Manorwood Homes

Lince Lane,
Kirtlington

Project Reference: 2207-015/TN/01A

Technical Note

TITLE:
**On-Site -
Swept Path Analysis of a
Refuse Vehicle**

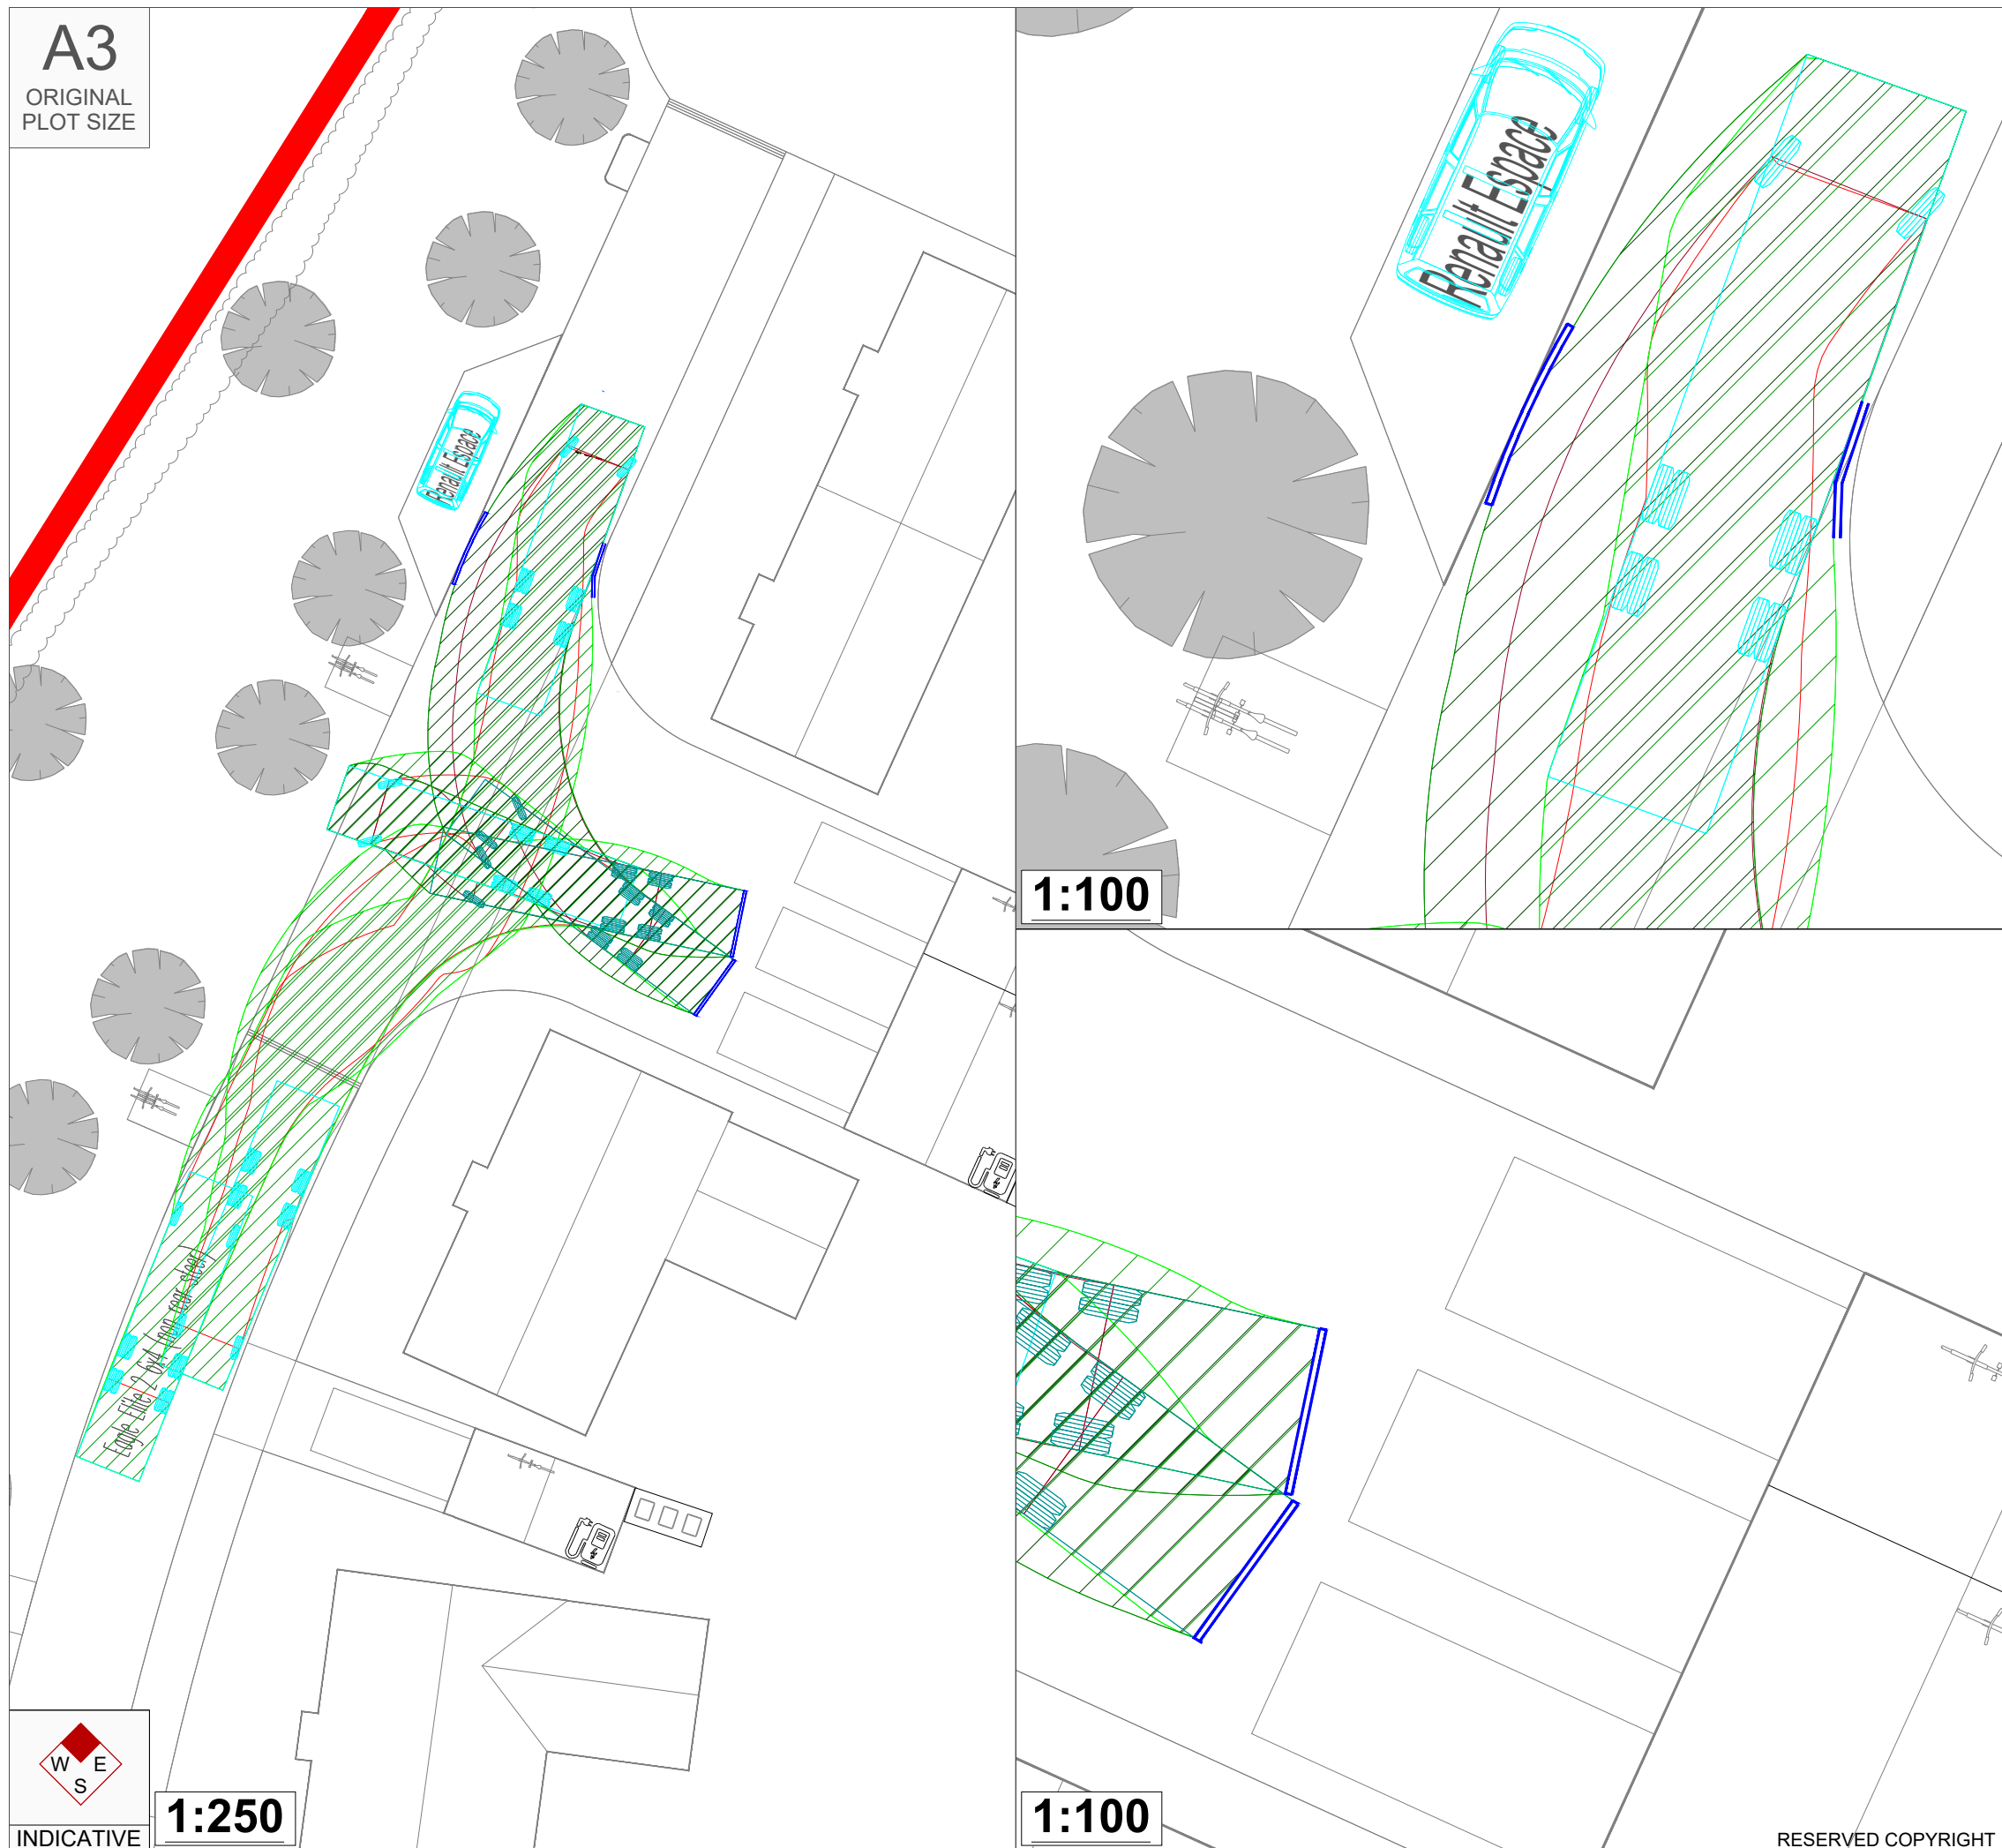
“Given the positioning of the access to this site, it is not going to be possible for refuse vehicles to stop on the A4095. Therefore a swept path analysis for a 11.6m refuse vehicle should be carried out, to prove that it can manoeuvre around the site safely. The vehicle must not overhang any of the footways and should also be tracked passing a parked car.”

- 2.28 Notwithstanding that the refuse vehicle used within the Transport Statement is consistent with CDCs guidance, new swept paths for a larger refuse vehicle have been undertaken. The vehicle tracking software does not have a 11.6m refuse vehicle, the closest being a 11.5m. TPA drawing 22-7-015 SP07A shows the 11.5m refuse vehicle, with a 0.1m ‘buffer’ turning within the site, with no overhang of parking spaces or footways.
